## Mask Set Errata 4

# MC68HC912DG128 Microcontroller Unit

This errata provides information applicable to the following MC68HC912DG128 MCU mask set devices:

- 0K50E

Figure 1. Representation of Normal start-up condition

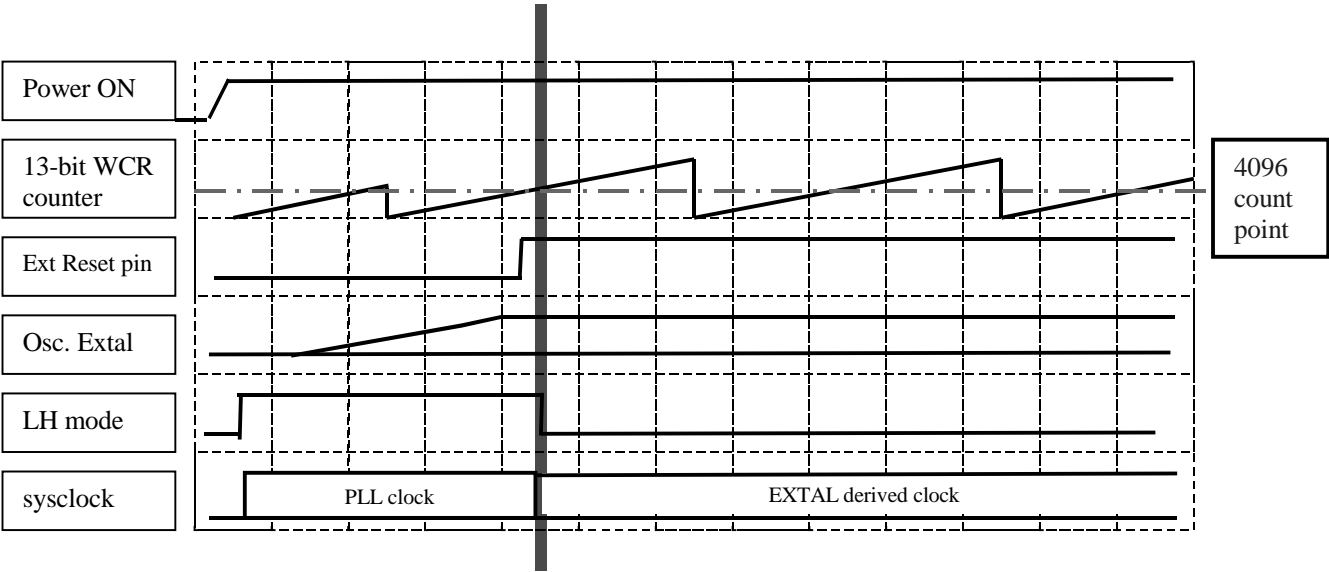
Common practice for the start up mode of operation of HC12 microcontrollers is for the external RESET line to be held active until such time as the crystal has stabilized at its operating frequency. On release of the external RESET line and when the WCR (counter register) reaches a count of 4096 cycles, normal operating mode is entered with the CPU clocked from the crystal frequency (see fig. 1).

Figure 2. Representation of unreliable start-up mode with slow crystal

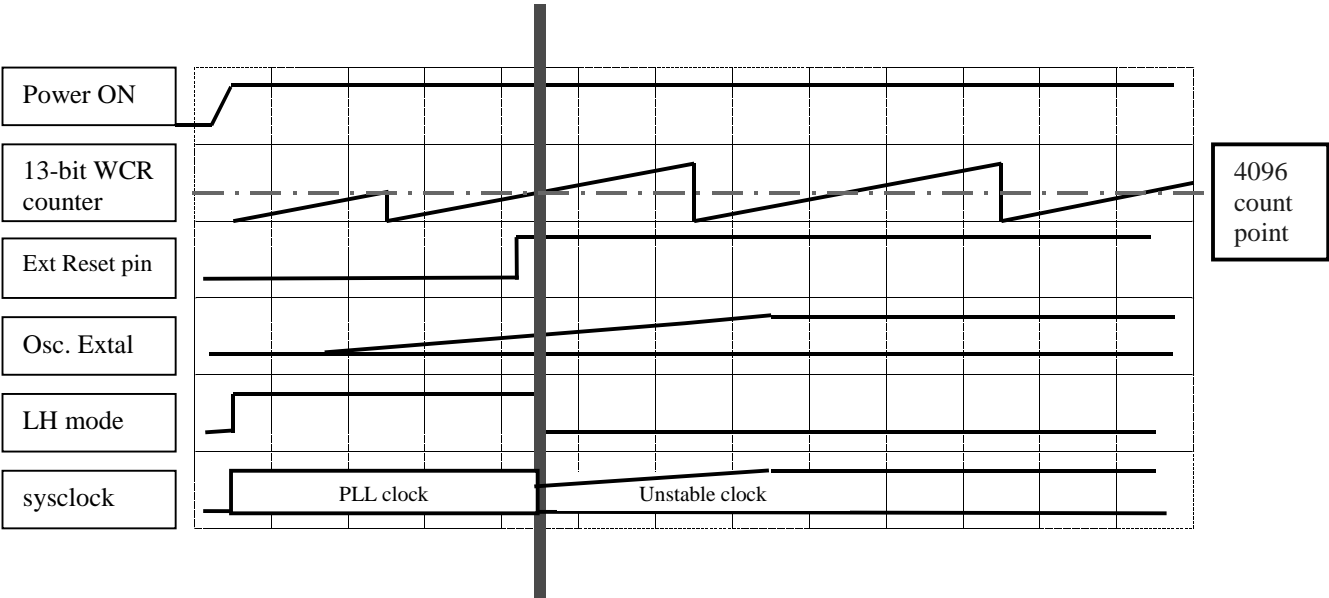
The HC12 mode of operation known as Limp-Home Mode (LHM) is enabled when the VDDPLL pin is at VDD and is entered if for any reason the external crystal ceases to oscillate. During this mode the CPU will be clocked from the free-running VCO clock of the PLL (at a nominal frequency of 1MHz). If LHM is enabled during the start-up phase (i.e. VDDPLL=5V, NOLHM bit=0) and the external RESET line is not held active until after the crystal frequency is stable then the device starts up in LHM since no crystal oscillations will be detected. This situation can arise with short reset periods and/or crystals that exhibit slow start-up characteristics.

For the first 4096 cycles i.e. during the internal reset period, Limp Home mode will be de-asserted if oscillator activity is detected by the clock monitor circuit -due to the asserted Reset signal there can be no CPU activity during the Reset phase. Following release of the external or internal POR RESET in LHM (which ever is later) the crystal oscillator is sampled by the clock monitor circuit after another 4096 VCO clock cycles and at intervals of 8192 clock cycles thereafter until the crystal is deemed to be operating. If the crystal oscillator is showing activity at the time it is checked then it will be deemed to be good, even though it may not have fully stabilized, and LHM will be de-asserted. This can cause the device to switch from LH mode to normal mode with the CPU clocked from an unstable signal from the crystal oscillator (see fig. 2) resulting in unpredictable function of the CPU.
